PRODUCT CHANGE NOTICE

PCN Number : 246

Product Category : PSG01484 3.5mm Audio Plug.

Issue Date : 20 - DEC - 2021

Figure 1

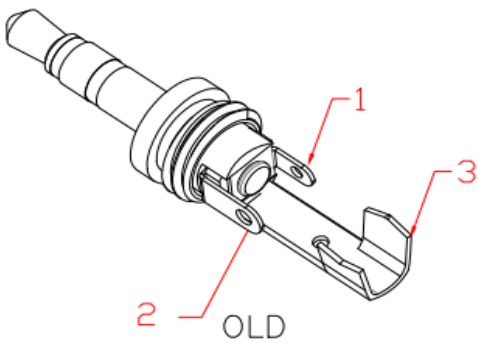
Detail of Change : The internal welding structure has been changed as detailed below in figure 1 to figure 2. This change has been made to improve the efficiency of the production process as well as enhancing quality control resulting in the defective rate being greatly reduced from 15-20% to 3-5% of a production run.

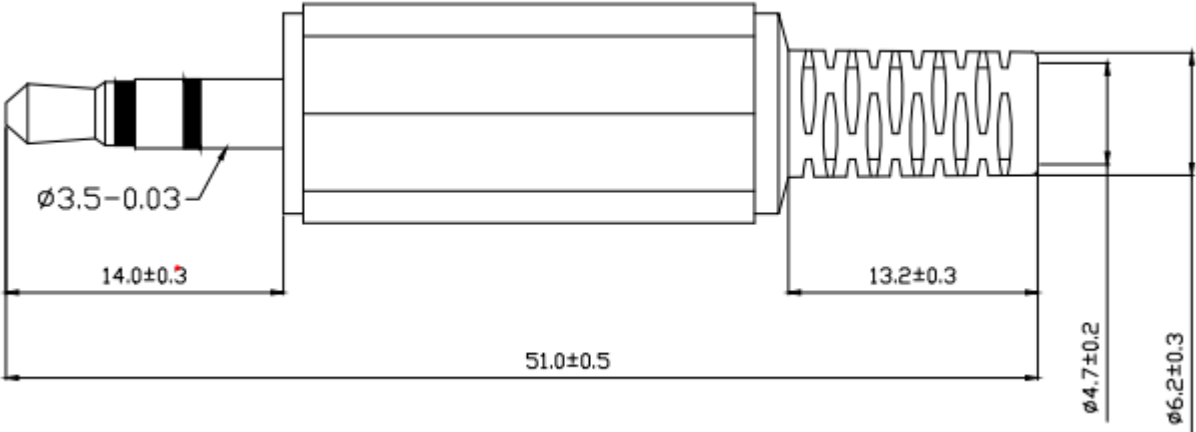
Change to Form Fit Function : There is no change to the fit, form or function of the product. The external dimension remain exactly the same as before as shown in the diagram below.
